M9502A-04-S

S E R V I C E N O T E

M9502A AXIe 2 Slot Chassis

Chassis carry handle may come off while handling

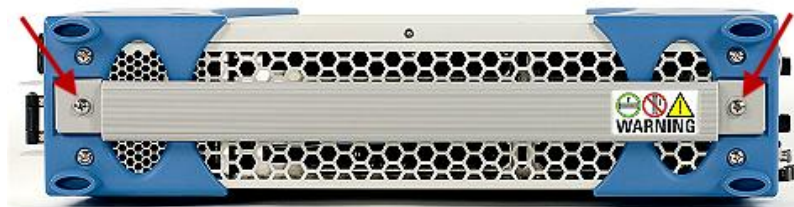
Chassis carry handle screws may become loose over time causing the carry handle to come off while handling.

Carry handle screws with locking mechanism will prevent this issue. Picture below shows the screw with locking mechanism included in the M9502A and M9505A Handle Screw Kit (M9502-80001).

Replace the screws on the chassis carry handle shown in the picture below. Use 8.7 to 10 in-lbs torque to tighten the screws.
